# CITY OF LAREDO HISTORIC DISTRICT/LANDMARK BOARD PUBLIC NOTICE OF REGULAR MEETING

Public hearing and consideration of a motion to consider exterior alterations, which include the creation and addition of a door and two windows on the east side of the building on Lots 6, 7, 8, 9, & 10, Block 34, Western Division, located at 1016 Iturbide Street (Suite 9). This property is within the Old Mercado District.

#### HD-002-2024 District VIII

PROPOSED View on Elevation (ADD EXIT DOOR & 2 SIDE LIGHTS WINDOWS)

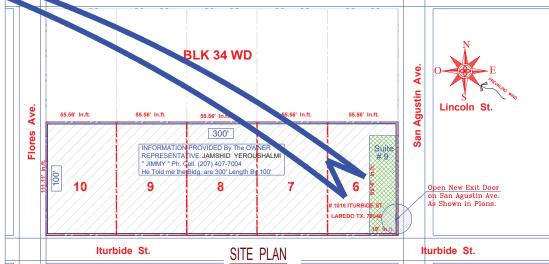
Staff <u>does not support</u> the exterior alterations, which include the creation and addition of a door and two windows located on the east side of the building, for the following reasons:

- 1. As per the Secretary of the Interior's Standards for Rehabilitation and Illustrated Guidelines for Rehabilitating Historic Buildings, cutting new openings on character-defining elevations or cutting openings that damage or destroy significant features is not recommended. Therefore, the proposed renovations do not conform to the Secretary of the Interior guidelines. The new addition of the two windows and the door does not preserve the historic facade of the building.
- 2. As per the City of Laredo Historic Urban Design Guidelines states to preserve the integrity of each individual historic structure, by preserving its character defining features and by avoiding alterations that would remove or obscure its historic character. Therefore, the addition of a door

- and two windows, where none have existed, will alter the symmetry of the facade and does not preserve the historic character of the building.
- 3. As per the City of Laredo Historic Urban Design Guidelines states the storefront should not be altered or obscured. Therefore, the new addition of the door and two windows will alter the storefront historic character.

#### If approved, Staff recommends the following:

- 1. The location of the proposed door and windows should be centered on the east side of the building.
- 2. The proposed door and windows in material form and function shall resemble the doors on the storefront located on Iturbide Street.
